INDIANA DEPARTMENT OF TRANSPORTATION

STANDARDS COMMITTEE MEETING AGENDA

RE: Agenda for the August 18, 2005 Standards Committee Meeting

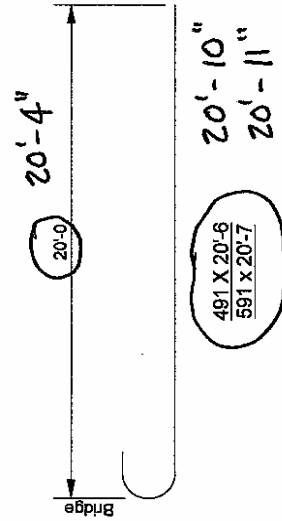
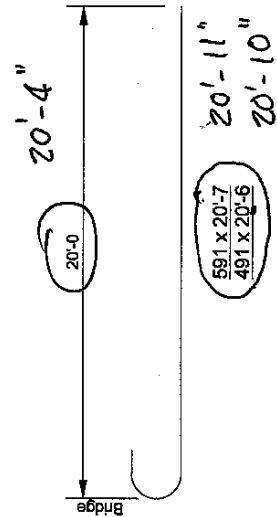
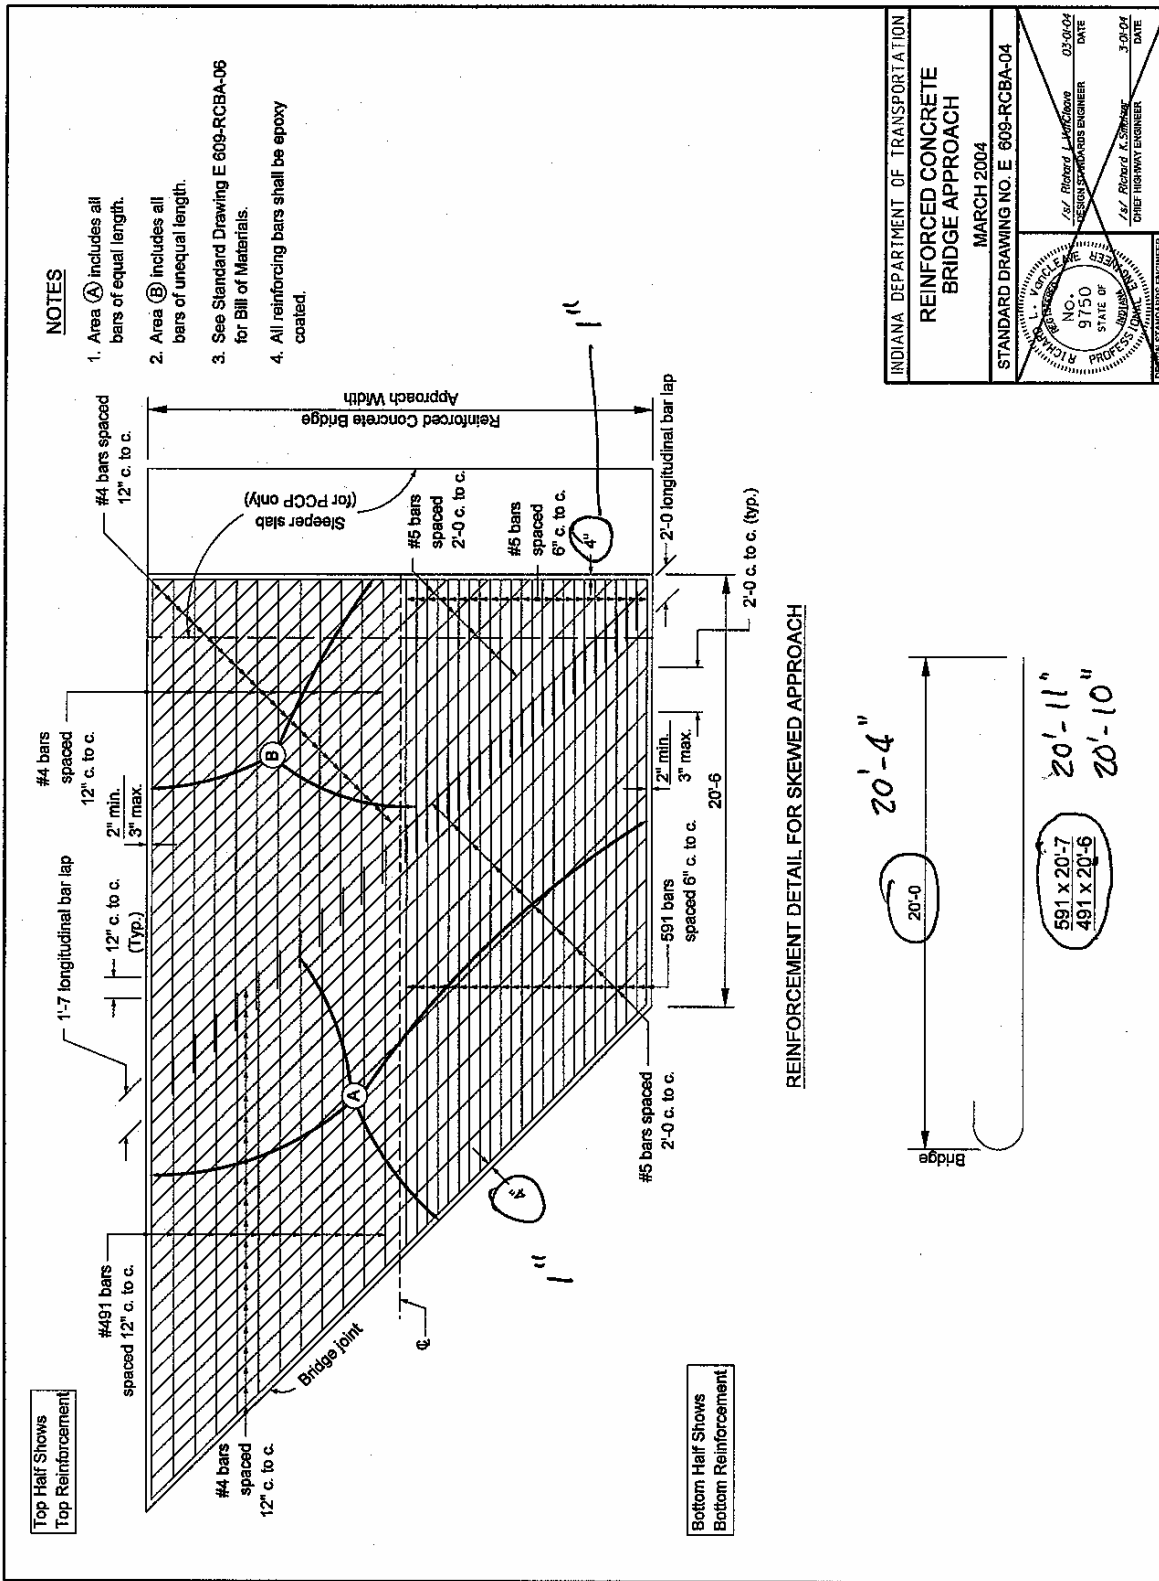
609-RCBA-03 Reinforced Concrete Bridge Approach
609-RCBA-04 Reinforced Concrete Bridge Approach
609-RCBA-07 Reinforced Concrete Bridge Approach Pavement Ledge Detail
